## **Access Compliance Report Public Rights-of-Way** (Curb Ramps)

Intersection ID: 30366 Main Street: EASTWYCKE PLACE DR **Cross Street: SUBIRA LN** Location: SW Initial Pass/Fail: Fail **Overall Compliance: No Severity Score: ADA ID: F79FE0EE1259** Ramp Type: PerpDiag 8.75

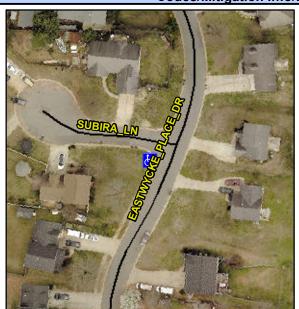
Possible Solutions: Remove & Replace Curb Ramp With Two New Directional Ramps or Equivalent. Surveyor Notes: N/A PROW/ADA: R304.5.1
